**City of Bellevue
Development Services Department
Land Use Staff Report**

Proposal Name: Lower Coal Creek Flood Hazard Reduction Project

File Number: 16-145319-LO

**UPPER SKAGIT KEY CULVERT REPLACEMENT
STREAM BYPASS AND ESC PLAN**

**UPPER SKAGIT KEY CULVERT REPLACEMENT
HABITAT LOG PLACEMENT AND SOIL
LIFT DETAILS**

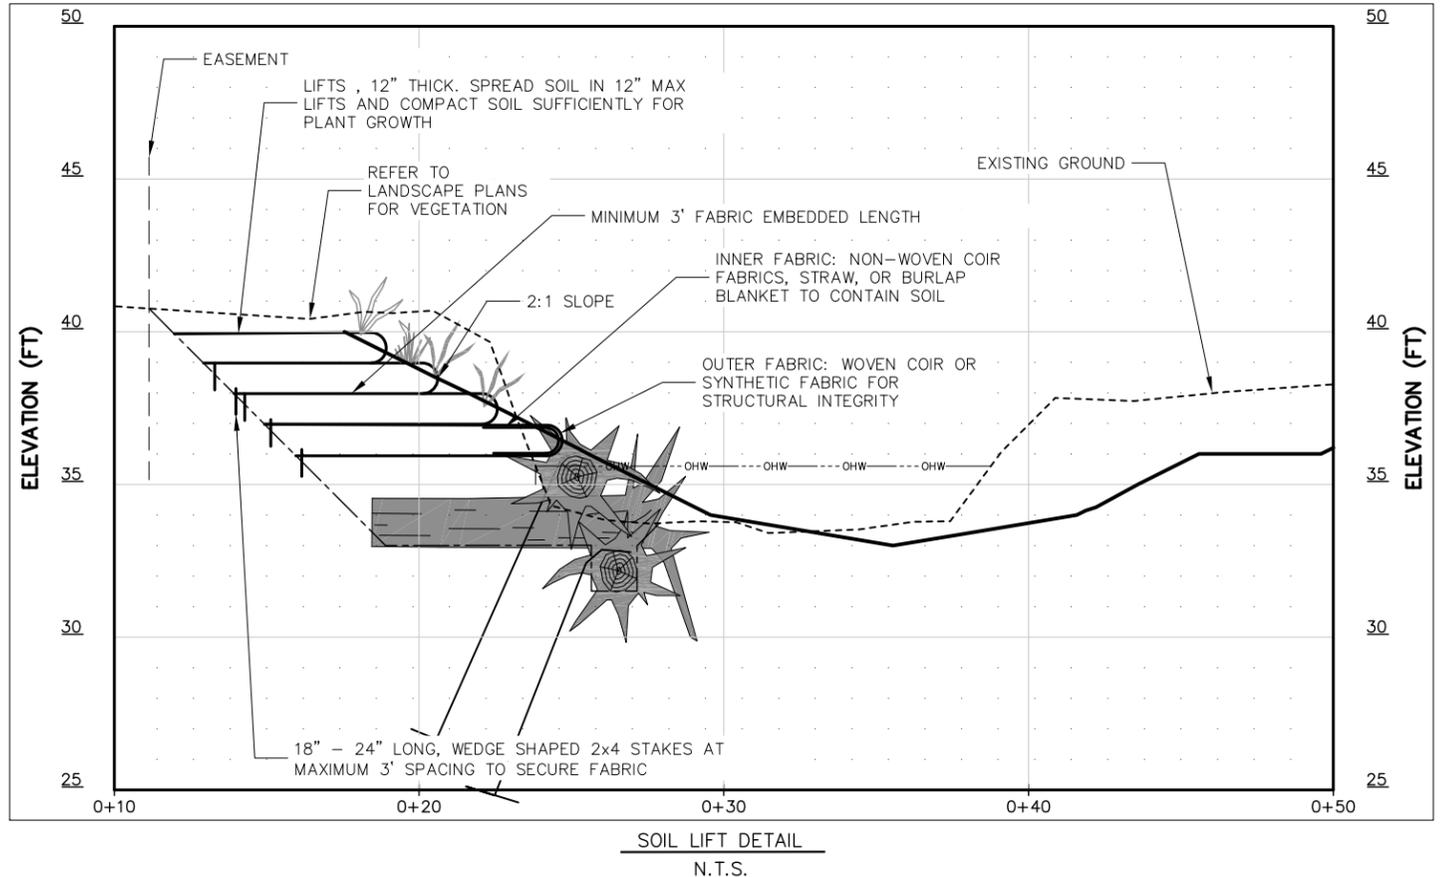
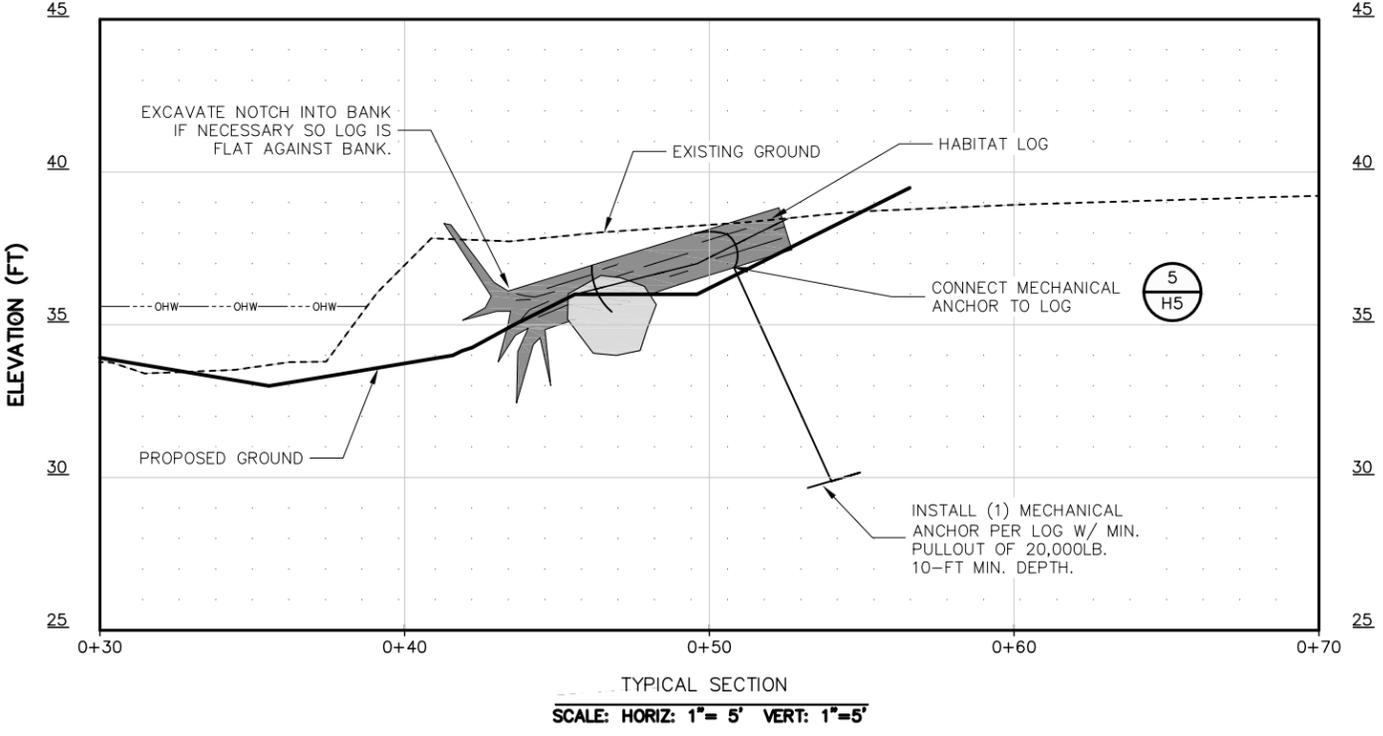
The proposed 2 x 1-ton boulders shown in the wood design (sheet 7 of 30% drawings) is a concern, too, as these boulders will harden the bank and reduce scour in the margins that create habitat; reduce access to interstitial spaces for juvenile salmon and are considerably larger than what is found in the natural stream bed substrate currently (see Figure 15; D90 surface sediment is approximately 115 mm or 4.72 inches). In summary, these designs are not very fish friendly. Wood should be used as the dominate feature within the wetted width for bank stabilization and habitat mitigation, not the proposed oversized rock.

Riparian conditions in the referenced upstream reach of Coal Creek are very different than conditions in the project reach in lower Coal Creek where residential properties abut the channel and City ownership is limited to the

existing road rights of way. In respect to the upstream reach referenced in the comment, that reach of Coal Creek flows through a natural greenbelt area that is entirely owned by the City.

The design reflects the existing land use and associated risk factors that occur in the project area, which is very different than the conditions that occur upstream. The wood design is based on reach-specific hydraulic and hydrologic modeling and the associate forces the installed wood are expected to encounter. The proposed boulders are provided to anchor the structures and will be buried in the structures, streambanks and channel. These sites also have extremely poor subsurface conditions, which will preclude the use of mechanical anchors. Also, the right of way and drainage easement are narrow with limited space for installation of wood structures. As a result, wood structures need to be relatively compact.

Wood Detail Comment

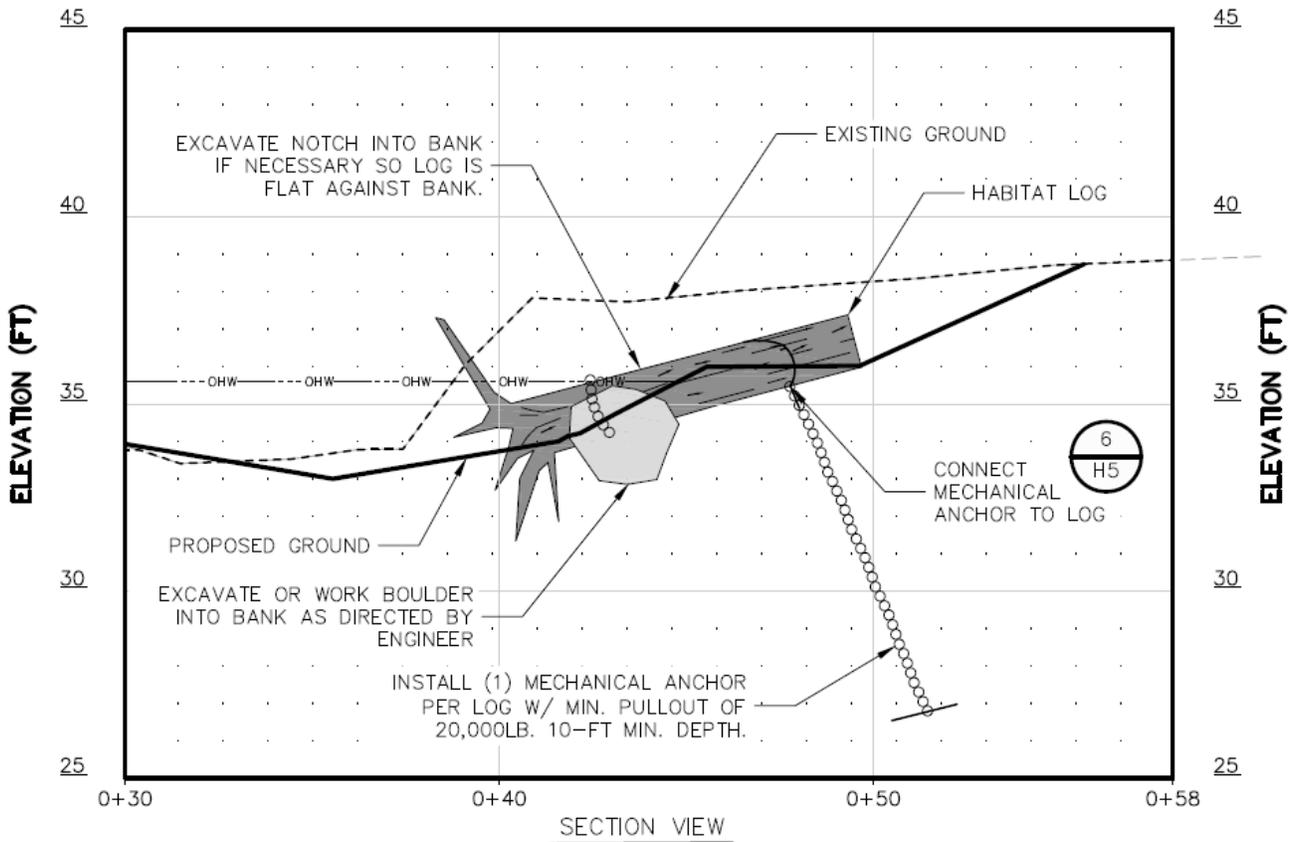
With respect to the wood design, the revised habitat log detail shows a very limited amount of the mitigation wood within the ordinary high water mark. The mitigation wood (41 pieces proposed) should be placed such that a minimum of 1/3 of the log length. The rock that is used for ballast and stability should be set back into the bank and not exposed to flows. Both of these design changes are needed to maximize habitat benefits to salmon (particularly juveniles) and to minimize the creation of salmon predator habitat. The wood design is an important component because as noted in our comments and the responses, it is unlikely that wood will come from upstream sources in a large part due to the trash rack on the I-405 culvert upstream which collects wood that would otherwise transport to this portion of Coal Creek. This wood is typically not relocated downstream to our knowledge.
